This house is historically significant and is listed on the City's Historical Resource Inventory. According to Santa Clara's Preservation Ordinance, any proposed alterations of houses on the HRI must be found to be in compliance with the *Secretary of the Interior's Standards for Rehabilitation* ([Rehabilitation as a Treatment and Standards for Rehabilitation—Technical Preservation Services, National Park Service \(nps.gov\)](https://www.nps.gov/rehabilitation)) in order to be declared categorically exempt from further environmental review under the requirements of CEQA. But, as a bonus, if this proposal is revised so that it can be found to be compliant, then the Owner may wish to apply for a Mills Act Contract. I will leave it to Staff to explain the tax benefits of obtaining such a contract with the City.

File: // HLC\_Mtg\_2021-07/1511Harrison/1511-Comments.docx

Interior Remodel for  
 Nguyen Residence  
 1511 Harrison Street  
 Santa Clara, CA 95050  
**NEW FLOOR PLAN**

**NEW FLOOR PLAN**

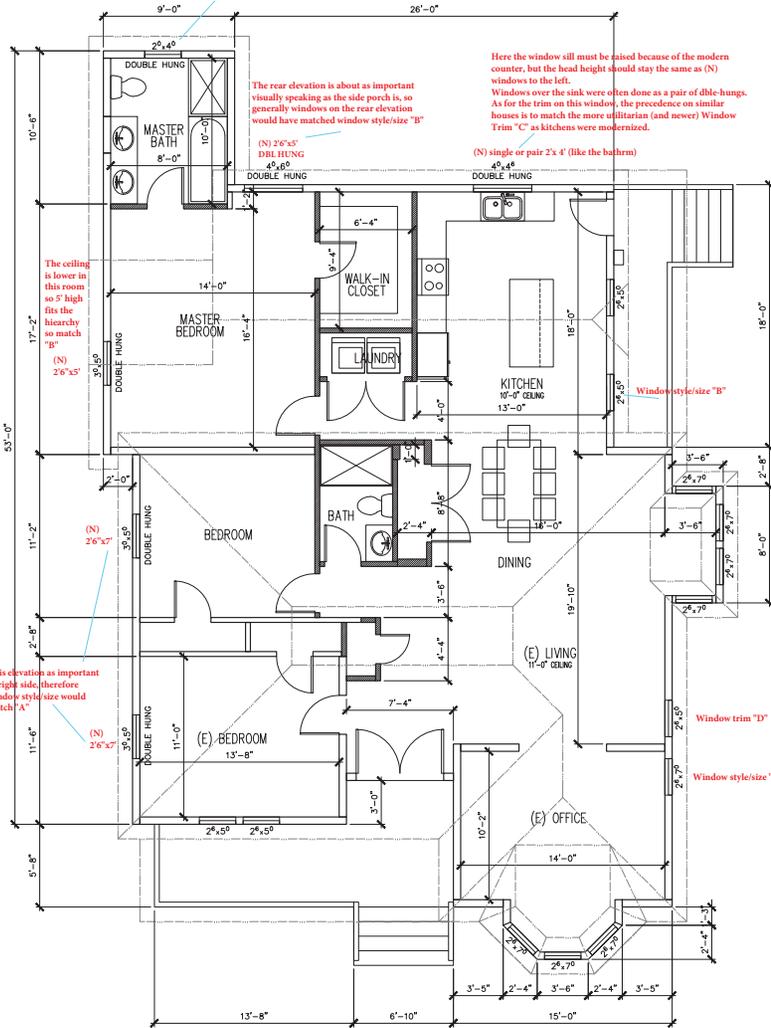
We'll call this new window: Size "C" (keep head hgt same as others on this side of hs, but raise sill.) But trim style should be style "D" as it is of lesser importance.

The rear elevation is about as important visually speaking as the side porch is, so generally windows on the rear elevation would have matched window style/size "B"

Here the window sill must be raised because of the modern counter, but the head height should stay the same as (N) windows to the left. Windows over the sink were often done as a pair of double hung. As for the trim on this window, the precedence on similar houses is to match the more utilitarian (and newer) Window Trim "C" as kitchens were modernized.

(N) single or pair 2'x4" (like the bathrm)

The ceiling is lower in this room so 5' high fits the hierarchy so match "B"

(N) 2'6"x5"

This elevation as important as right side, therefore window style/size would match "A"
